DEVIATION REVIEW AND DECISION FORM

Address of Subject Property (Street Number/Name): 0 Stepler Road
Tax Schedule ID(s) #: 6100000464
Legal Description of Property: SE4NE4NE4 & NE4SE4NE4 SEC 23-11-66 & S2NW4NW4 SEC 24-11-66
Subdivision or Project Name: Abert Ranch

Figure 2
**Abert Ranch
Site Plan**
Abert Ranch (LSC #164890)

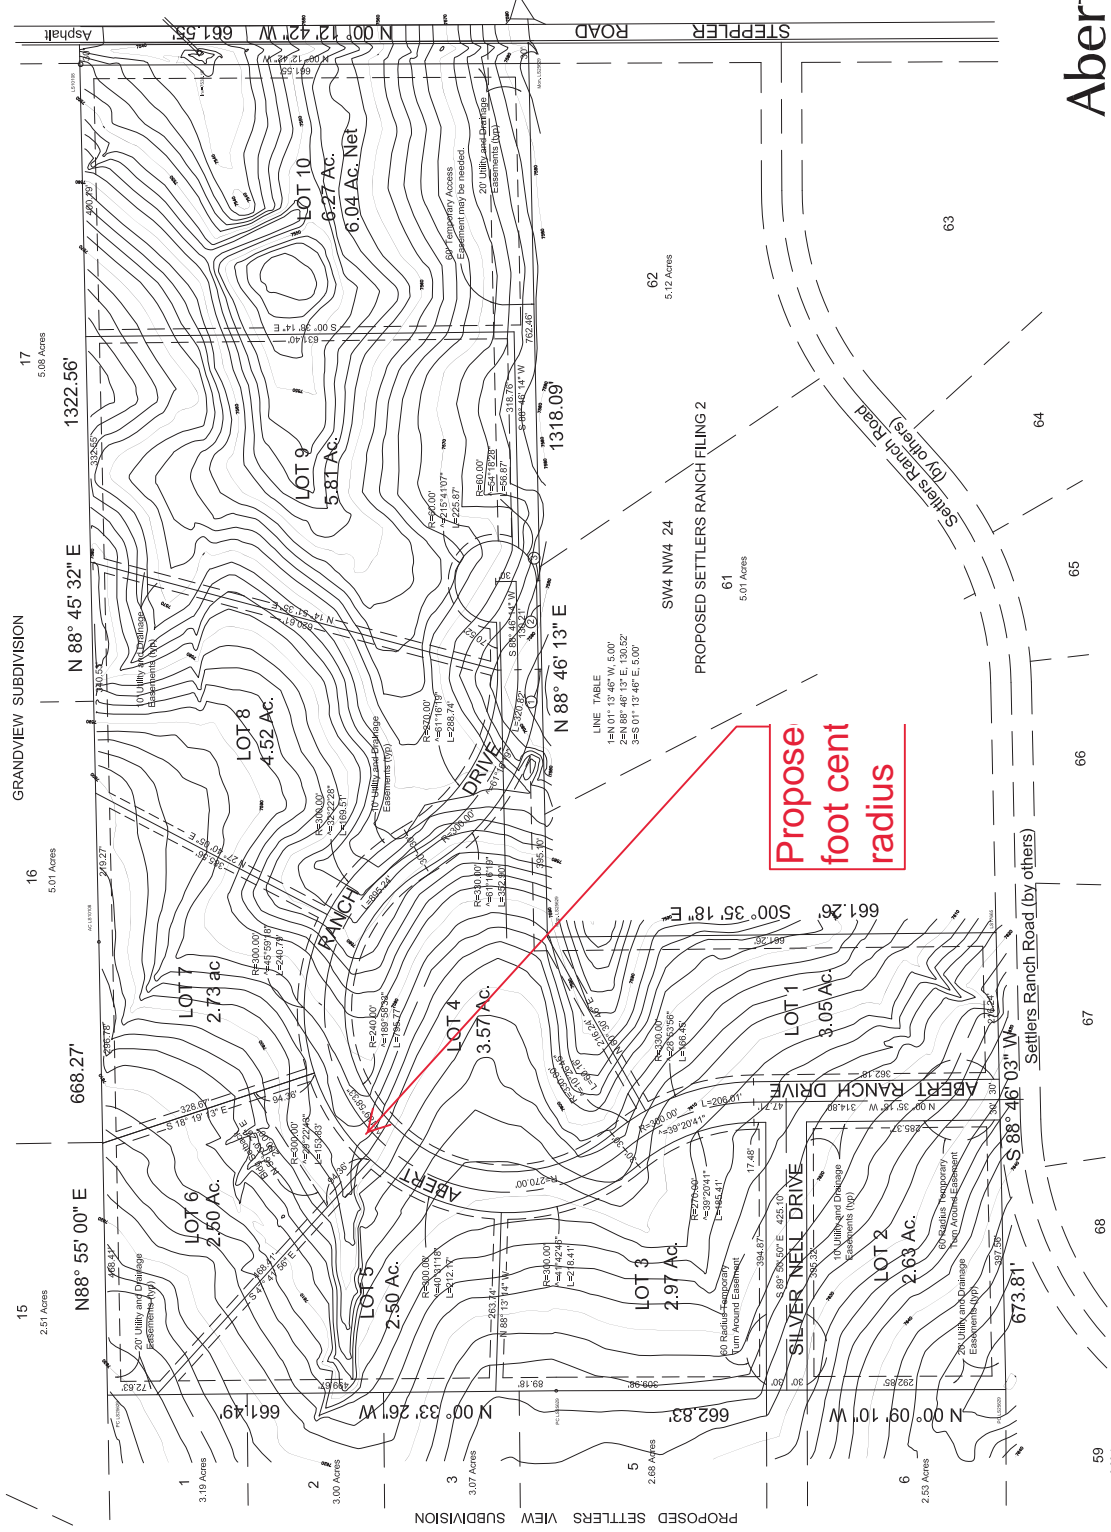
Proposed Nature and Extent of Deviation: The applicant is requesting a deviation to allow a 270-foot centerline curve radius for the proposed Abert Ranch Drive north of Silver Nell Drive (proposed). Please refer to attached exhibit.

Comparison of Proposed Deviation to ECM Standard: Proposed centerline radius is 270 feet. The standard is 300 feet (minimum).

The proposed centerline radius of 270 feet is 30 feet tighter than the standard 300-foot radius. This will not be problematic because 1) the overall length of the street is short; 2) The street length on either side of the proposed curves is short -- about 300 feet between the beginning of the first horizontal curve just north of Silver Nell Drive (which is shown to meet standards at 300-foot radius) and the planned intersection with Settlers Ranch Road to the south. On the east end of the street, the straight section between the end of the horizontal curve and the center of the cul-de-sac is only 130 feet; and 3) with only traffic generated by seven lots and no through traffic (short cul-de-sac street), the traffic volumes will be low.
